**From:** Donna Tisdale  
**To:** [Harris, Susan](#); [Koutoufidis, Nicholas](#)  
**Cc:** [Jacob, Dianne](#); [Wilson, Adam](#)  
**Subject:** Boulder Brush / Campo Wind DEIR PDS-ER-19-16-001  
**Date:** Sunday, January 12, 2020 10:45:18 AM  
**Attachments:** [Tisdale Campo Wind DEIS comments 7-8-19.pdf](#)  
[Snyder Campo Wind DEIS opinion 7-5-19.pdf](#)  
[Campo DEIS figures-7 Tisdale.pdf](#)

## CAMPO WIND / BOULDER BRUSH DEIS – OPPOSITION COMMENTS

Subject: Campo Wind Draft Environmental Impact Statement (EIS) with Boulder Brush Facilities  
Draft EIS Review and Opinion

**FIGURE 14b**  
Impacts to Vegetation Communities and Landcovers  
Campo Verde with Boulder Brush Habitat Biological Technical Report

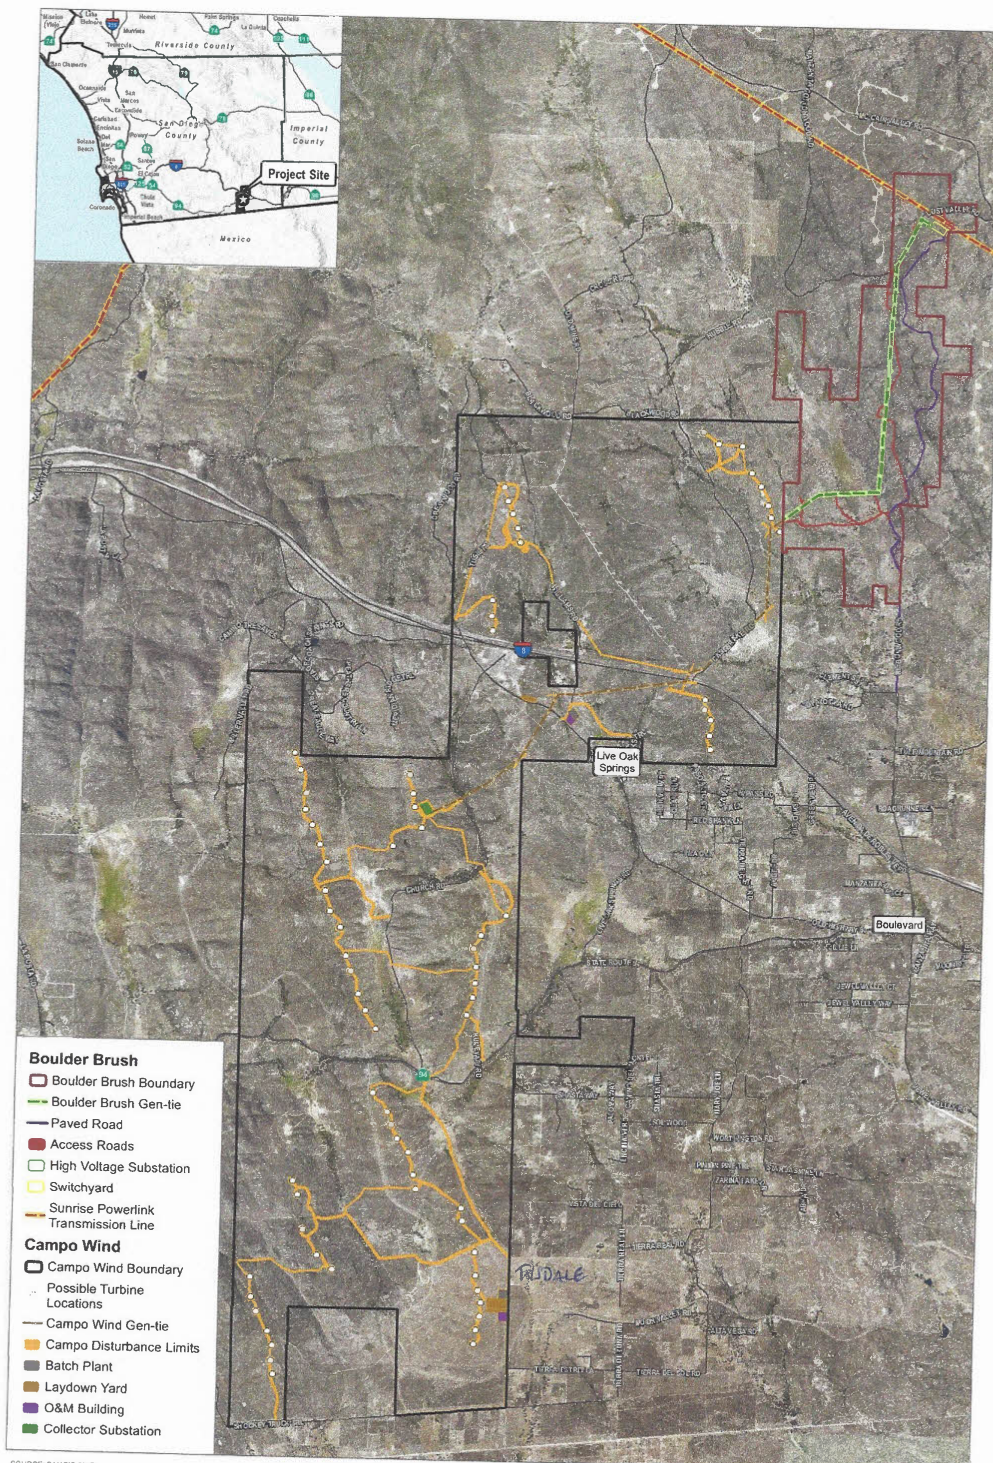
Figure 2-4 and Figure 14bx give a closer view of those facilities next to our place. 14bx shows our cleared pasture (1/4 mile boundary) and our chaparral covered property (1/4 mile boundary) immediately south, with rental house nestled in the oaks. 14 bx also documents golden eagle flight over the Campo Wind site and our place. This aerial photo also shows the Fordyce home to the north and just the edge of the Peterson home on the upper right edge of photo. There are other homes/families not in the photo.

**FIGURE 2-1A**

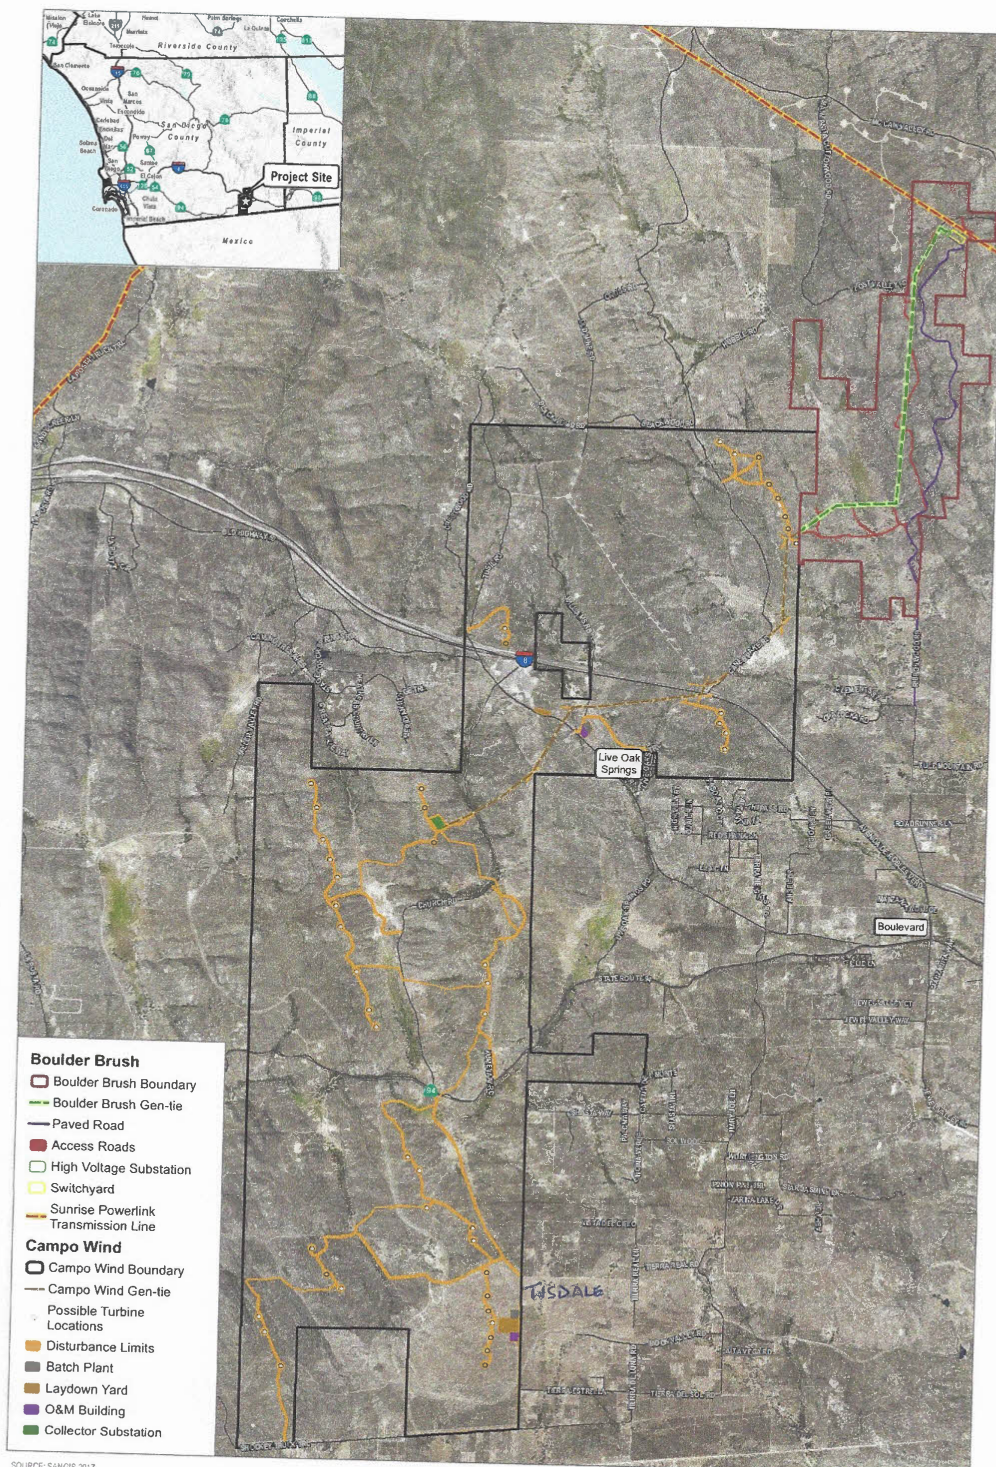
Both Campo Wind DEIS Alternatives 1 and 2 (figures 2-1A & 2-1B) include seven wind turbine sites, a cement batch plant, construction laydown yard, and O&M building right next to our properties. No coincidence there. We prefer Alternative 3 –NO PROJECT.

FIGURE 10  
 2010 Quino Checkerspot Butterfly Survey Results  
 Campo Wind Project Biological Technical Report

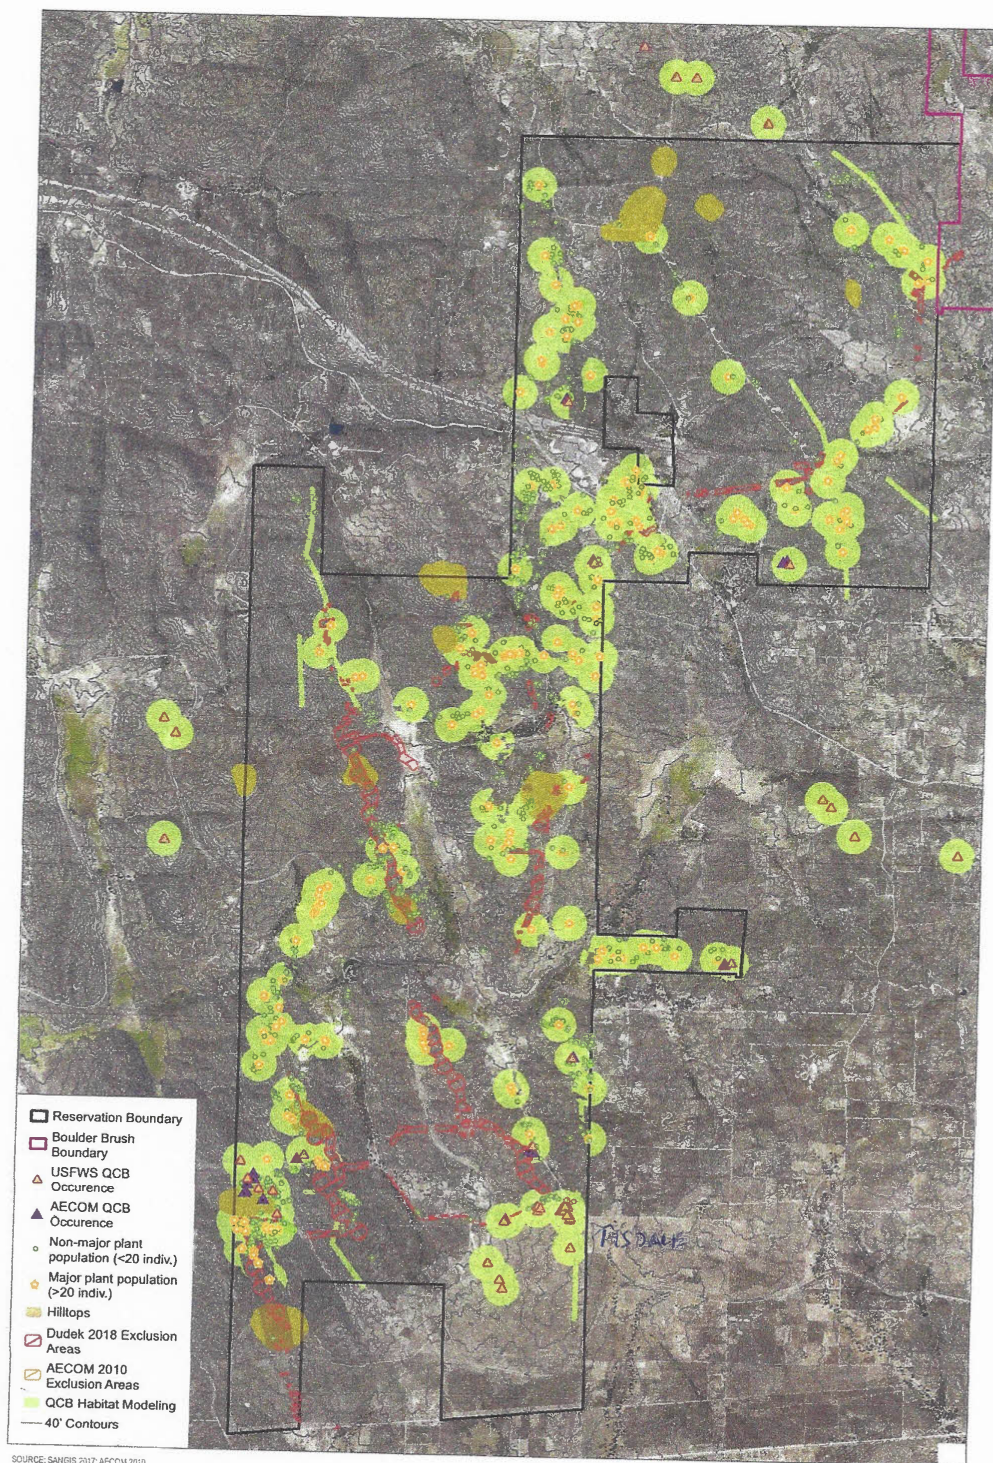
Figures 10 and 11 show the suitable Quino Checkerspot Butterfly (QCB) habitat and some of QCB field observation locations on the Campo Wind site next door. Attached is a 2008 map of QCB sitings from the 2010 Campo Landfill Supplemental DSEIS in that same area next to us. The 2008 map also shows the same well field that Campo Wind proposes to use.

**Figure 1 - FTA Operational Noise Impact Criteria**

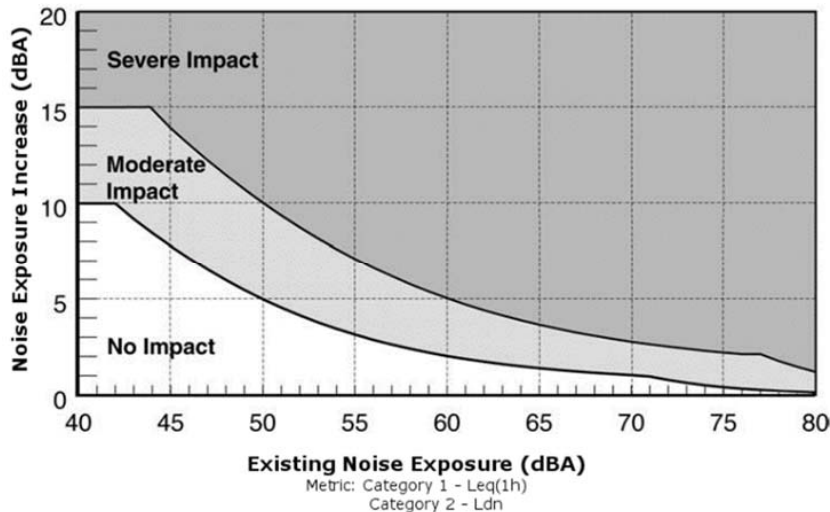
The County ordinance No. 9662 allows hourly average levels up to 50 dBA during daytime hours (7 a.m. to 10 p.m.) and 45 dBA during nighttime hours (10 p.m. to 7 a.m.). The equivalent  $L_{dn}$  based on these hourly daytime and nighttime limits is 52 dBA. We note that the BLM criteria document<sup>14</sup> indicates that an  $L_{dn}$  of 35 dBA can be expected in a typical rural environment. Consequently, if for example the existing  $L_{dn}$  is 37 dBA, then applying only the County noise limit would result in a Severe Impact (i.e., cause a 15 dBA increase) using the FTA relative criteria. Since the DEIS fails to accurately characterize the existing ambient as discussed in Section 3 below this is a real possibility.

**Figure 2 - Example of Amplitude Modulation**

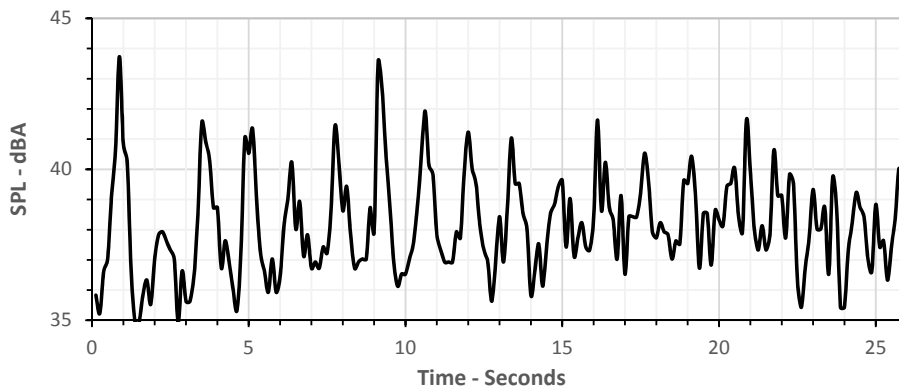
Measurements<sup>20</sup> conducted in the Project area demonstrate that the existing wind turbines generate amplitude modulated noise. Figure 2 illustrates amplitude modulation measured at a distance of 4,400 feet from the closest wind turbine at Tule Wind with peak-to-peak variation ranging from 4 to 9 dBA. These measurements demonstrate the presence of “excessive amplitude modulation” (peak-to-peak variation of 4 dBA or more) as defined by Cooper<sup>21</sup> or “enhanced amplitude modulation” (variation of 6 dBA) as characterized by Oerlemans<sup>22</sup>.

The DEIS addresses the impact of amplitude modulation by citing a study by RSG<sup>23</sup> that seems to minimize the severity of this phenomenon contrary to the evidence in Figure 2 above. Whereas the RSG study cited notes that modulations depths are rarely above 4 dB, the measurement at 4,400 feet from a Tule wind turbine indicates modulation depths up to 9 dB or *excessive* modulation under either Cooper’s or Oerlemans’ definition.

**Figure 3 - Example of Infrasound Measured in the Vicinity of the Project**

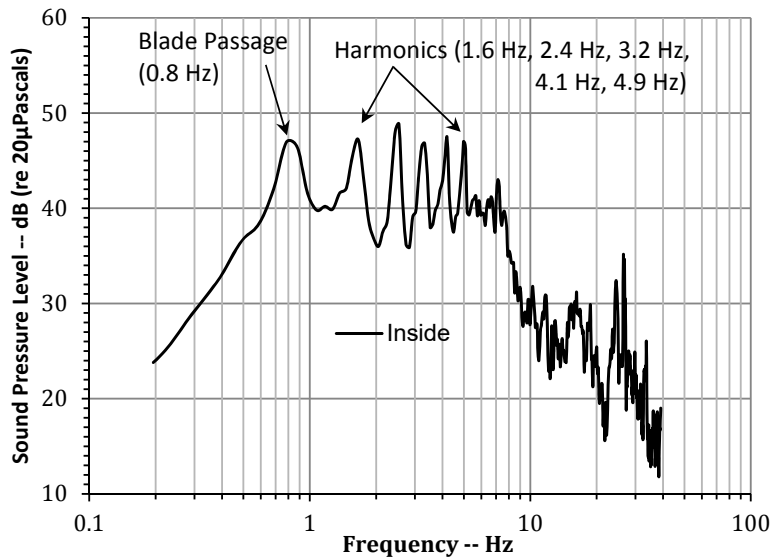
An example shown in Figure 3 illustrates infrasound spectra of existing wind turbines measured in the vicinity of the Project under low wind conditions. It should be noted that infrasound tends to increase with wind speed. The infrasound spectrum in Figure 3 is a classic example of noise produced by a machine with blades (e.g., helicopter).

typically last for only a few seconds. The spectral data in Figure 3 and Figure 4 were obtained from recorded samples that lasted for several minutes. The analytical methodology used to obtain these data minimizes any effects of very short term events that are random in nature. This misconception also ignores the fact that any sound generated by small earthquakes would be very low in magnitude (i.e., the ground is generally a poor radiator of sound). Furthermore, ground radiated sound from small earthquakes would produce a “broadband” spectrum and not one that is tonal in nature.
